# Access Compliance Report

## Public Rights-of-Way

Intersection ID: 10033749	Main Street: OVERLOOK_MOUNTAIN_DR	Cross Street: N/A	Location: NE
ADA ID: 94A160C1594D	Ramp Type: Perp	Initial Pass/Fail: Fail	Overall Compliance: No
Severity Score: 12.5			
Codes/Mitigation Info/Possible Solution		Field Measurements/Component Compliance

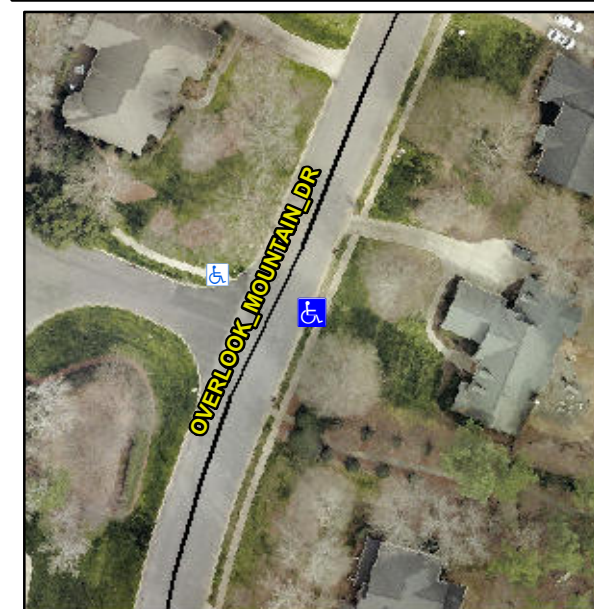
Compliance	Description	Data	Compliance	Description	Data
N/A	Ramp Length (in)	94.0	No	Ramp Slope (%)	8.4
Yes	Ramp Width (in)	48.0	Yes	Ramp XSlope (%)	0.1
N/A	Flare Type LT	N/A	N/A	Flare Type RT	N/A
N/A	Flare Slope LT (%)	N/A	N/A	Flare Slope RT (%)	N/A
N/A	Flare Traversable LT?	N/A	N/A	Flare Traversable RT?	N/A
N/A	Landing Length (in)	N/A	N/A	DWS Provided?	N/A
N/A	Landing Width (in)	N/A	N/A	DWS Contrast?	N/A
N/A	Landing Slope (%)	N/A	N/A	DWS Length (in)	N/A
N/A	Landing X Slope (%)	N/A	N/A	DWS Full Width?	N/A
N/A	Landing Curb? (Y/N)	N/A	N/A	DWS Offset (in)	N/A
N/A	Shared Landing?	N/A			
N/A	Gutter Ponding?	N/A	N/A	Gutter Slope (%)	N/A
N/A	Gutter Lip Ht (in)	N/A	N/A	Gutter X Slope (%)	N/A
N/A	Painted X Walk1?	No	N/A	Painted X Walk2?	N/A
	X Walk 1 Direction	To NW		X Walk 2 Direction	N/A
N/A	X Walk 1 Width (in)	N/A	N/A	X Walk 2 Width (in)	N/A
	X Walk 1 Slope (%)	0.7		X Walk 2 Slope (%)	N/A
	X Walk 1 X Slope (%)	3.1		X Walk 2 X Slope (%)	N/A

**Remove & Replace Entire Ramp.**

**R304.2.2**
